The Nuclear Regulatory Commission's Double Standard: A Historical Overview of NRC's Inspection Requirements at Millstone 1, Turkey Point and Holtec's Palisades

Prepared by Arnie Gundersen, Chief Engineer, Fairewinds,
Expert Witness for Don't Waste Michigan, et al.

April 2, 2026

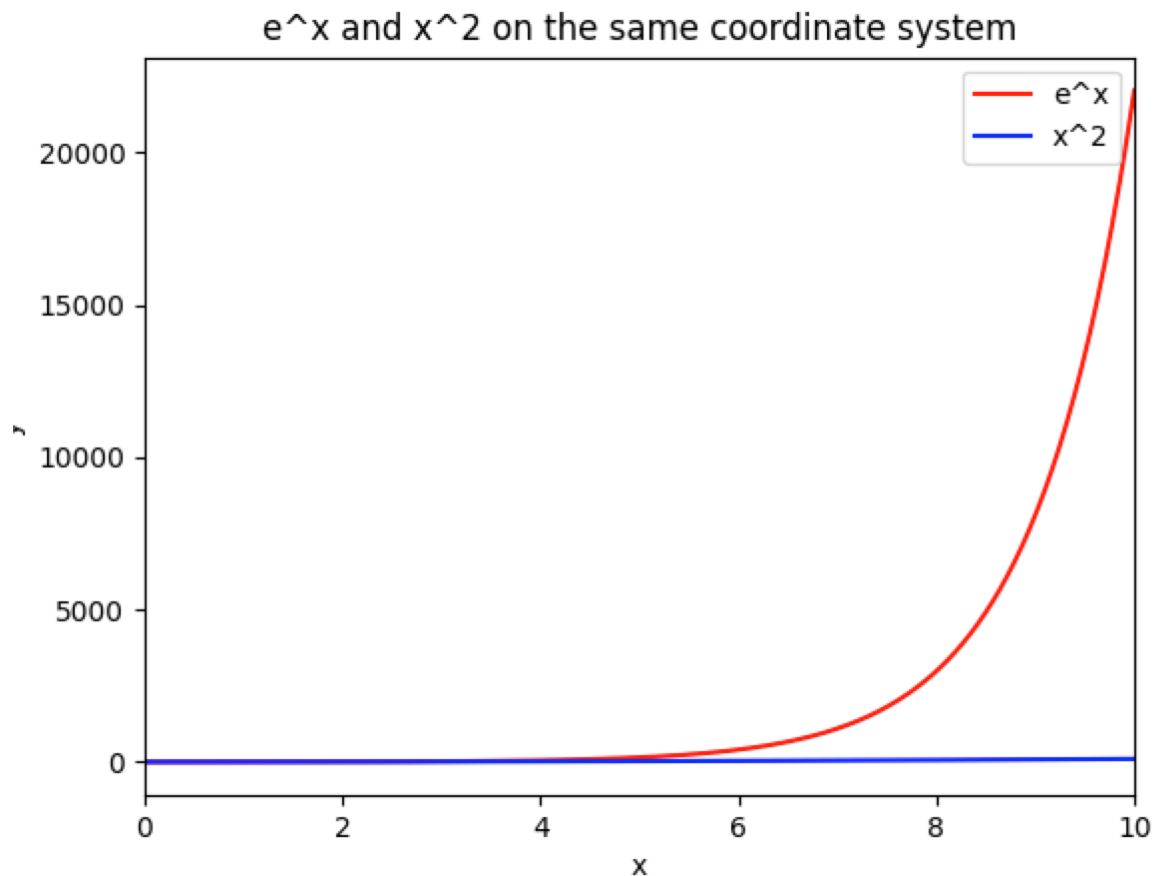
Exponential growth is much more dangerous than quadratic growth. Below is a visual comparison of the difference between quadratic growth and exponential growth:
